# Mechanical-Electrical-Plumbing Drawings for **HYPNO - CHICK RESTAURANT**

**HYPNO-CHIC RESTAURANT**

Re: TB-20-139; 255 Angler's Drive  
Narrative of Drawing Changes in Addm. #1

As requested, the following is a narrative of drawing changes on the recently submitted Addm. #1. The changes are also clouded on all the sheets submitted.

**KE100**

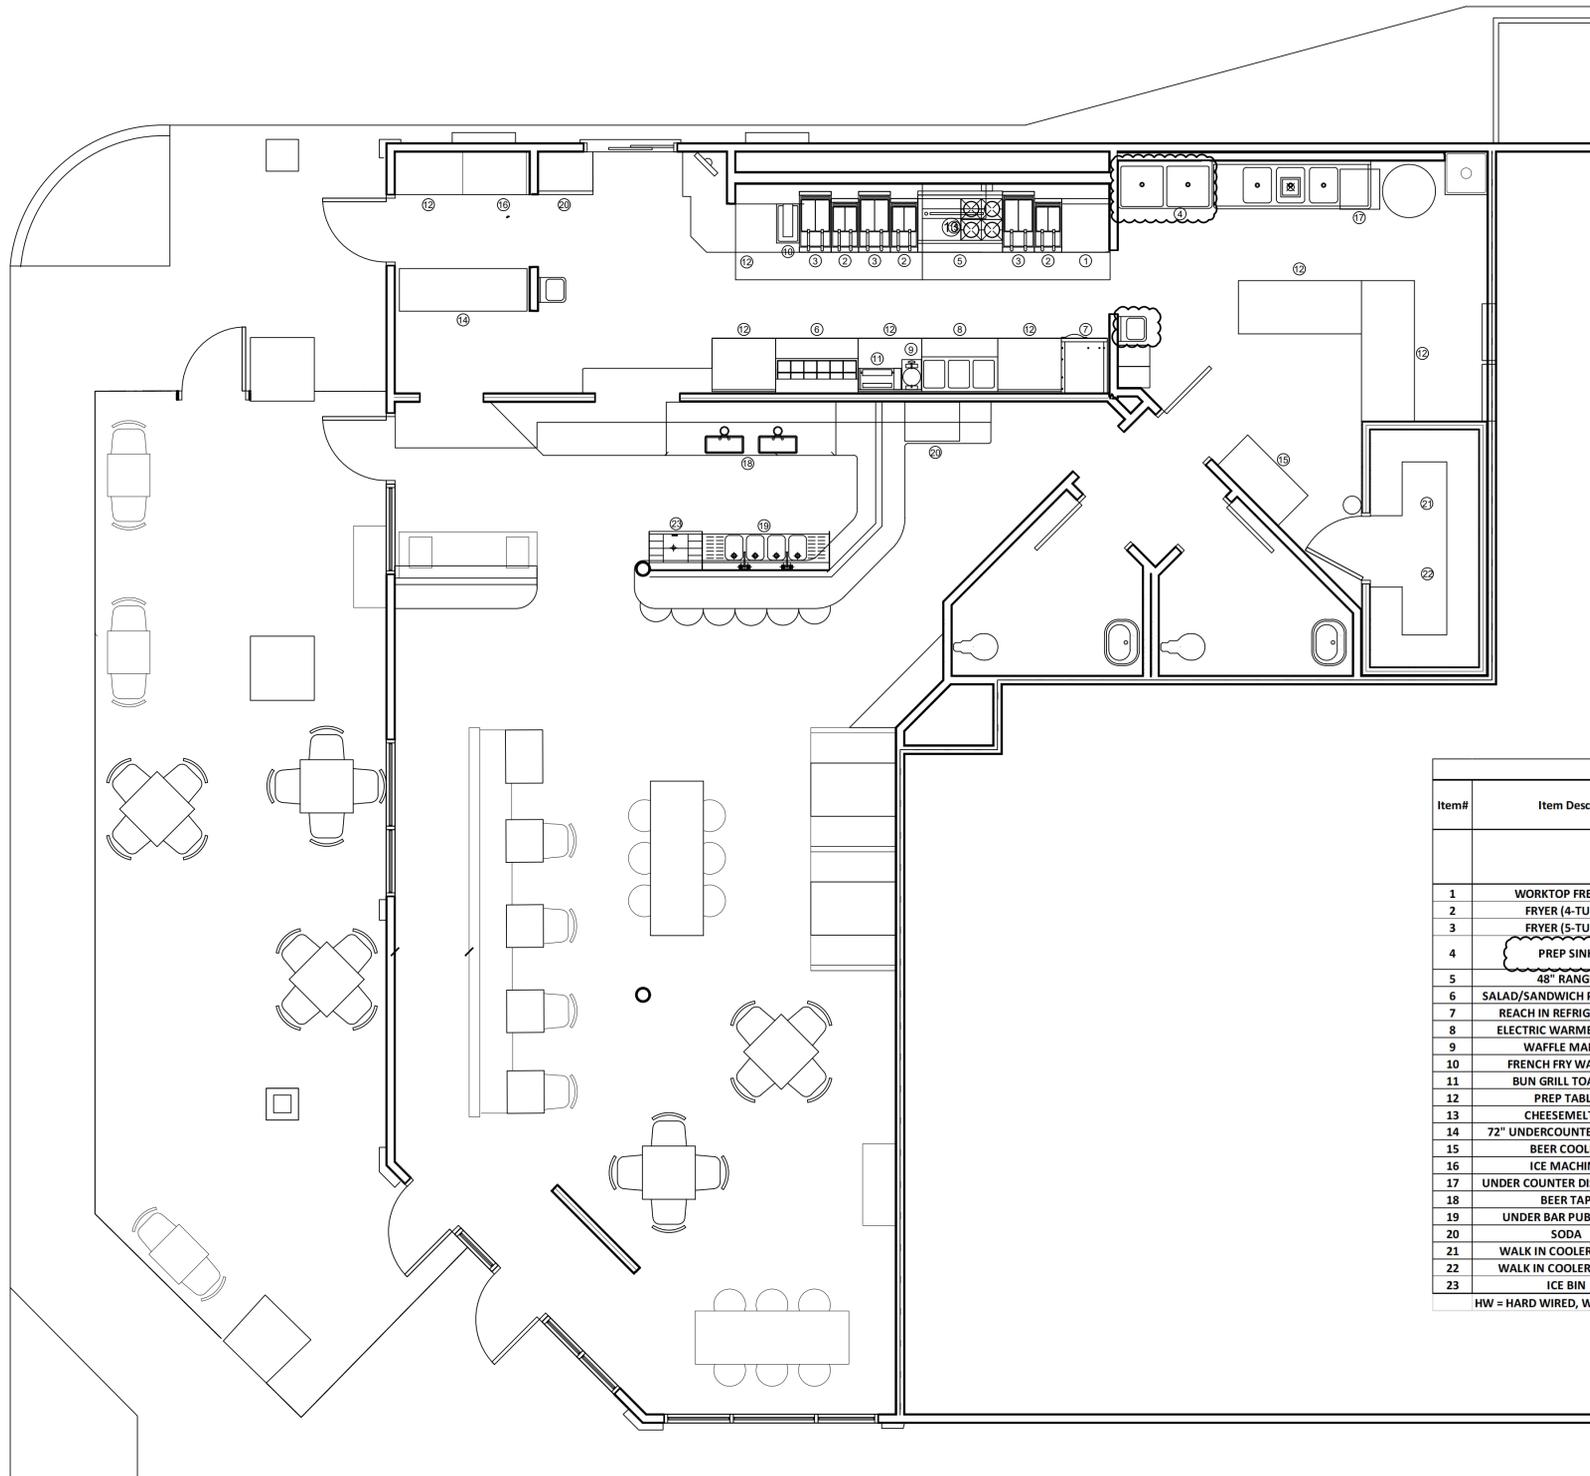
REVISIONS:	DATE:
ADDED PREP SINK, RELOCATED HAND SINK	3/25/2020

The other sheets simply show the sinks in their new locations as part of the background.

**PLUMBING PLAN**

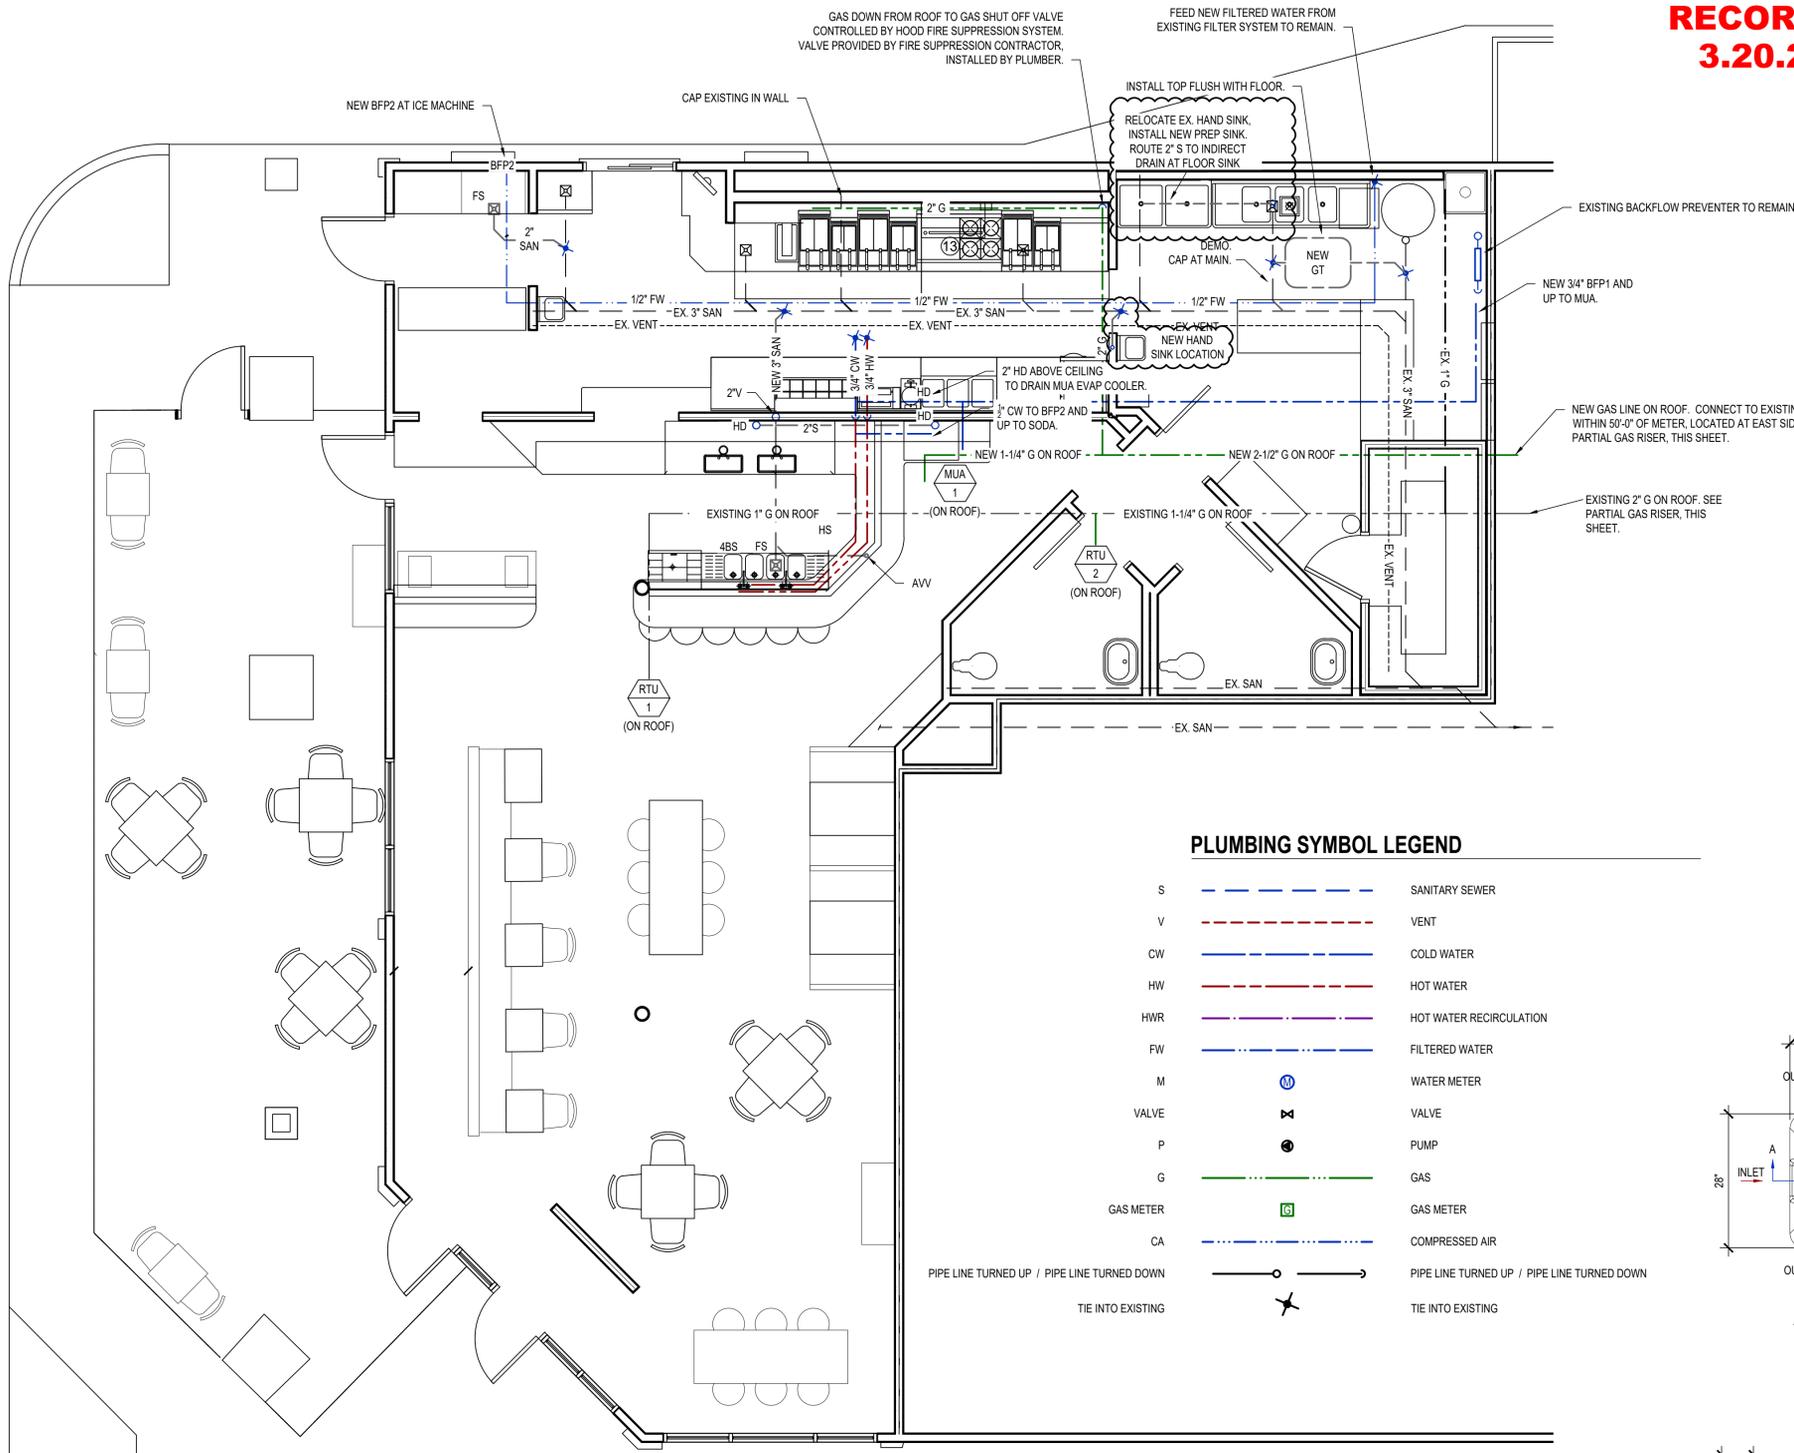
REVISIONS:	DATE:
ADDED PREP SINK, RELOCATED HAND SINK	3/25/2020

1. Hand sink was relocated
2. Prep sink was added.

The plumbing sheet P100 indicates the required plumbing changes.
